# UNITED STATES PATENT AND TRADEMARK OFFICE

APPLICATION NO.	FILING DATE	FIRST NAMED INVENTOR	ATTORNEY DOCKET NO.	CONFIRMATION NO.
10/642,430	08/15/2003	Peter C. Williams	22188/06671	9883

# Office Action Summary

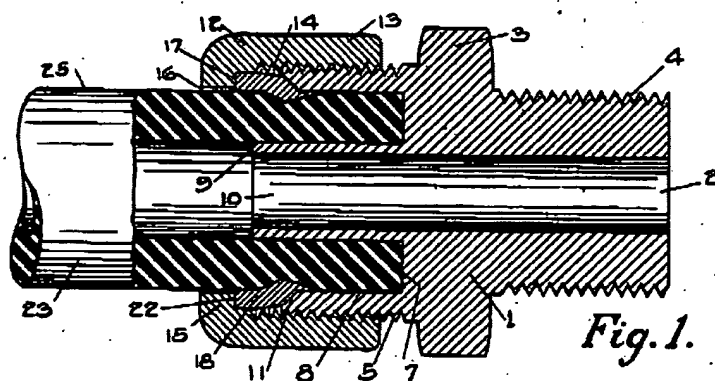
Claims 1-4,16-18,27,30 and 51 are rejected under 35 U.S.C. § 102(b) as being anticipated by U.S. patent 2,152,537 to Couty. The Couty fitting illustrates the features of the present invention with a fitting body 3 and nut 12 threadedly

joined. The body includes a camming surface 11 at an angle of 30-45 degrees with respect to the main axis of the body (page 2, line 25) and a ferrule 18 having a front end engaging the camming surface and a back end engaging a nut drive surface.

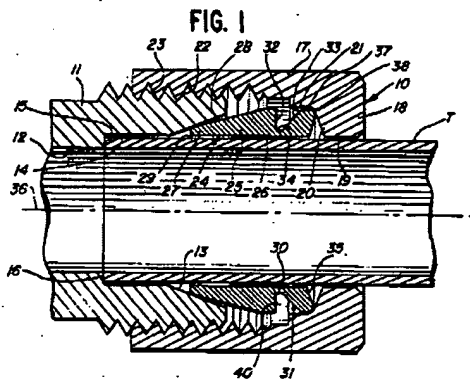
Claims 1-8,11-25,27-29 and 52 are rejected under 35 U.S.C. 103(a) as being unpatentable over U.S. patent 4,556,242 to Kowal et al. in view of U.S. patent 2,152,537 to Couty.

The Kowal et al. fitting discloses the claimed device except for the particular angle of the camming surface 28 on the body 11. As noted above, the Couty fitting discloses that it is known in the art to provide a *similar* type coupling wherein the camming surface on the body is between 30 and 45 degrees (see page 2, line 25). It would have been obvious to one having ordinary skill in the art at the time the invention was made to fabricate the camming surface angle 28 of Kowal et al. to be at an angle of between 30 and 45 degrees such as taught by Couty, in order to

provide a more secure coupling for the inserted tube due by optimizing the resultant compressive forces between the ferrule and the camming surface. As to claims 16 and 19 the size and material of the tube being at least .5 inches or the ferrule being made of stainless steel are features considered old and well known in the pipe coupling art such that one of ordinary skill in the art would readily recognize that pipes are routinely sized according to the desired need the selection of stainless steel in order to avoid corrosion is known, both to the point that they do not patentably define over the prior art as it is well within the general skill of a worker in the art to select a known material or size on the basis of its suitability for the intended use as a matter of obvious design choice.
